ITEM 6.1: ADMINISTRATIVE PERMIT – 212 Riverside – RGSP PCL RG-6 - Riverside Parking – FILE # PL19-0167

The applicant requests an Administrative Permit to improve a vacant parcel with off-street commercial parking and landscaping.

Figure 2: Wall Example

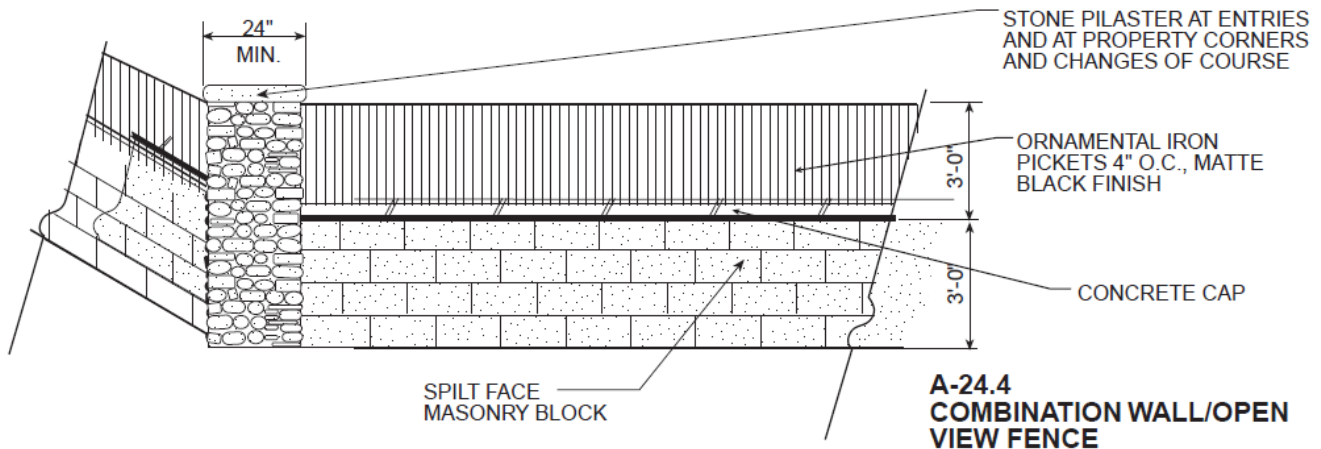
with appropriate design elements, such as fences, walls, and landscaping. Screening materials should not be opaque or block views of the parking lot from passing cars. The screening materials should maintain the visual continuity of the street wall adjacent to the sidewalk.” In keeping with this guideline, staff has requested that the applicant construct a knee wall with an attractive landscape area in front of the wall. This proposal allows visibility into the site over the wall, but also provides screening of the parking area. The applicant’s proposal to install a steel fence does not address the intent of the guidelines to provide screening of parking areas. Examples of this design can be found various City planning documents such as the Stoneridge Specific Plan design guidelines (Figure 2).

The proposed project does not conform to these two criteria. The proposed steel fence and green wall do not provide adequate screening to minimize the visual impact of the parking lot on the surrounding area. The tubular steel fence proposed by the applicant does not meet the intent of the guidelines in the RGSP. Staff worked with the applicant to develop a solution that enhanced screening of the parking lot from view such as a low wall or berm, as described in the specific plan. A low wall or berm allows visibility into the site, while also providing consistent screening. The applicant provided green wall examples with their proposal, but these do not appear to be compatible with the fence they are proposing and no details are given to adequately explain how the plants will be installed or maintained. The applicant did not follow staff guidance on providing screening for the site. Therefore, the proposed project is not consistent with the RGSP and the above finding cannot be made as proposed. Staff has added Condition #3 to the project to incorporate the low wall in order to make the finding for approval.

2. The project is approved as shown in **Exhibit A** and as conditioned or modified below. (Planning)
3. The project shall incorporate a knee wall with decorative metal fencing above in a design to be approved by the Planning Division. The design shall be similar to the fencing example shown in Figure 2 above. (Planning)
